Delegated Report		Analysis sheet		Expiry Date:	03/10/2024
		n/a		Consultation Expiry Date:	15/09/2024
Officer			Application Numbers		
Tony Young			1. 2024/3313/P 2. 2024/3453/A		
Application Address			Drawing Numbers		
Pavement outside 85 Chalk Farm Road London NW1 8AR			Refer to draft decision notice		
PO 3/4	Area Team Signature	C&UD	Authorised Officer Signature		
Proposals					
1. <u>Planning application</u> - Installation of a Pulse Smart Hub with integrated digital screens and emergency functionality including provision of defibrillators. 2. <u>Advertisement consent application</u> - Display of illuminated content on digital screens integrated within new communication Hub.					
Recommendations		1. Refuse Planning Permission 2. Refuse Advertisement Consent			
Application Types		1. Full Planning Permission 2. Advertisement Consent

Images 3 & 4 – proposed site location and streetscene (looking south-east on Chalk Farm Road)

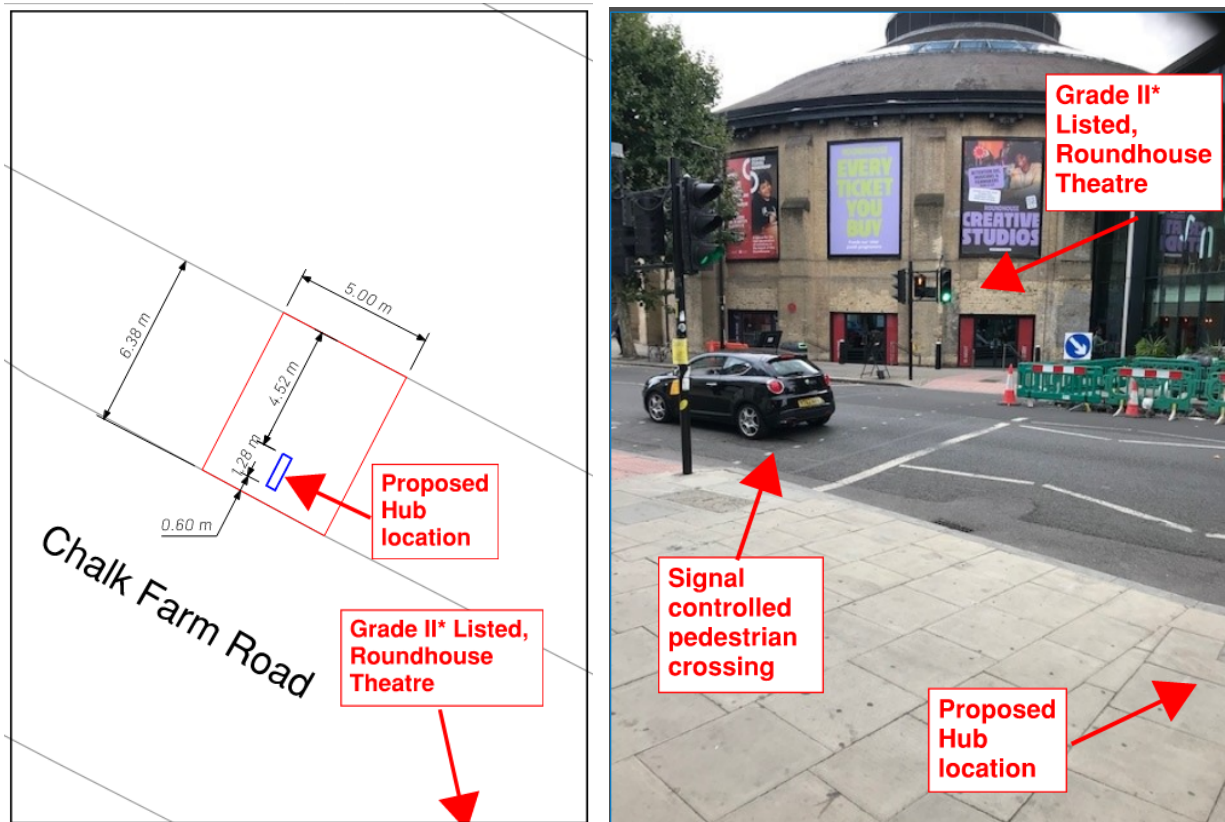
3.9 Although the site does not fall within a conservation area, it is located directly opposite the boundary of Regent's Canal Conservation Area. The Grade II* listed, Roundhouse Theatre, is also located directly opposite the application site.

3.10 The proposed hub structure is considered to be poor in design terms and appears to have been primarily designed around the inclusion of two large digital screens on each of the main elevations. It would seem from the images of the proposed hub included within the application submission (see Images 1 and 2 above) that the size of the hub unit itself has been determined by the dimensions of the advertising panels. As such, the two illuminated digital advertising display screens occupy the majority of area available on each elevation of the structure (facing north-west and south-east along Chalk Farm Road respectively).

Image 5 – comparison of different communication kiosks/hubs (proposed hub structure in red)

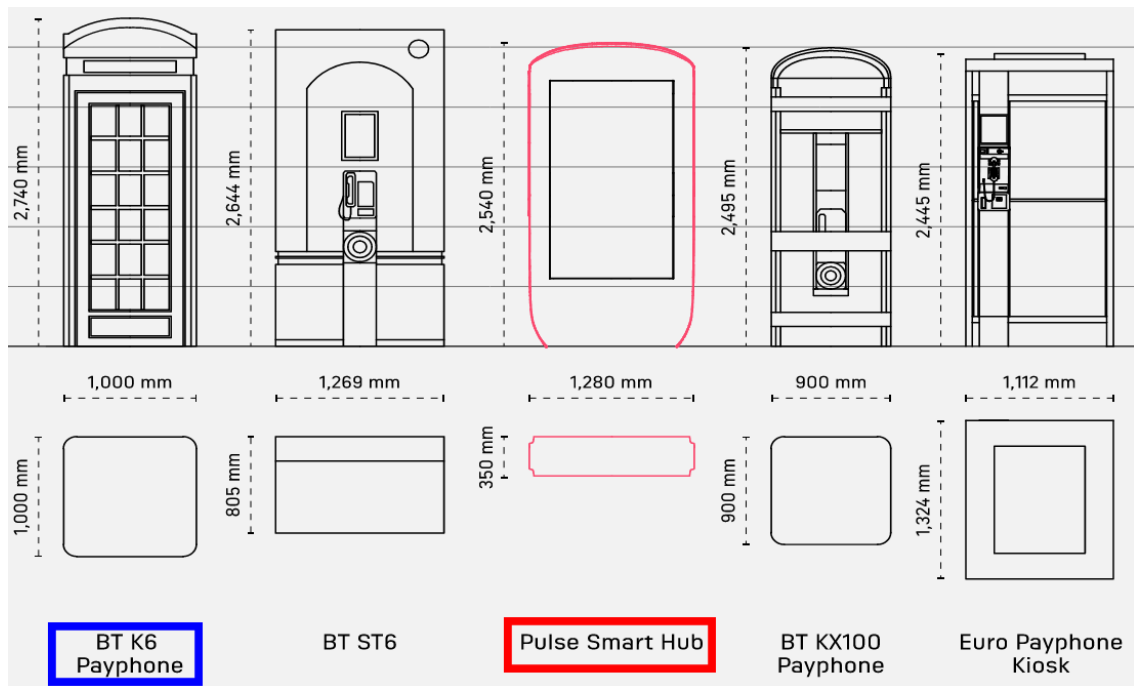
3.13 The dark grey anodised metal, black and clear laminated glass with textured fiberglass would have a shiny finish and incongruous contemporary appearance within the streetscene. While the applicant's planning statement describes the design of the proposed hub as referencing a traditional red phone box, it is the Council's view that the proposed structure bears little relation. Indeed, a comparison of both a traditional red phone box and the current proposal as shown in

the application submission not only shows a lack of similarity in design of them both, but also a substantially larger profile (see Image 5 below).

- 3.18 Whilst the proposed hub structure is shown in Image 5 above as having a smaller footprint than, say, a traditional red telephone box, this is primarily through a difference in depth rather than in width. Any difference therefore is not something that would be experienced by a pedestrian as the large width and profile of the proposed structure would be most noticeable and prominent to the pedestrian on approach, restricting their views and visual amenity in this context. Furthermore, it is emphasised that there is no kiosk or hub of any kind in situ in this location, and therefore, the applicant's comparison of footprint dimensions with a traditional telephone box (or indeed any other communications kiosk/hub) is considered to be mainly irrelevant as the proposals are not for a replacement structure, but rather would introduce a new item of street furniture to an area of public highway that is presently open and uncluttered by large or bulky items.

Image 6 – showing proximity of application site to signal-controlled pedestrian crossing (looking north-west on Chalk Farm Road)

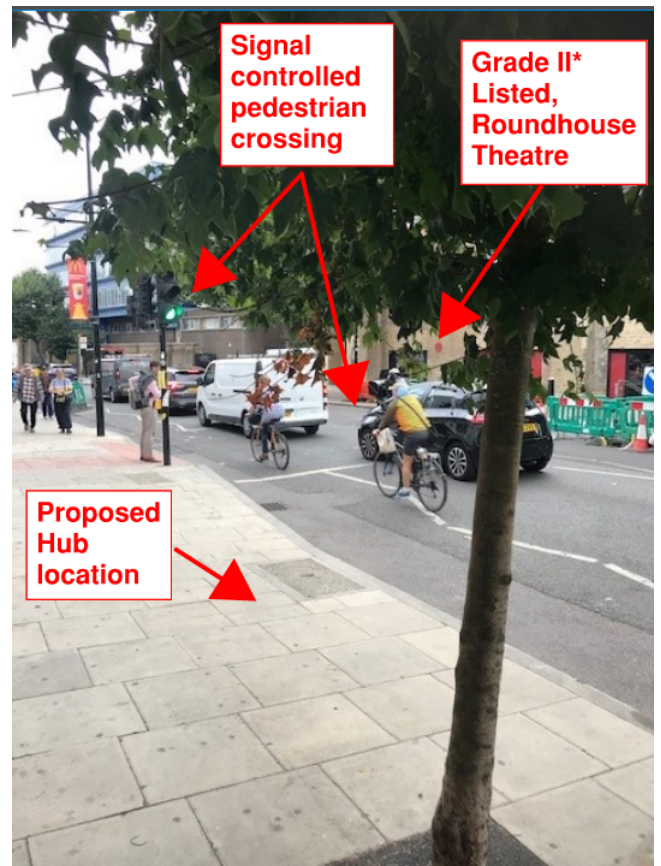
- 3.69 Images 6-8 below show the approximate position of the proposed hub location to a signal-controlled pedestrian crossing in context with the surrounding streetscene.

3.70 Images 6-8 above indicate that the proposed hub structure (with integrated digital advertising screens on both sides) would be installed within approximately 8m of a busy signal-controlled pedestrian crossing located to the south-east, contrary to the above Transport for London guidance. The approximate distance and degree of proximity is also shown in Image 9 below.
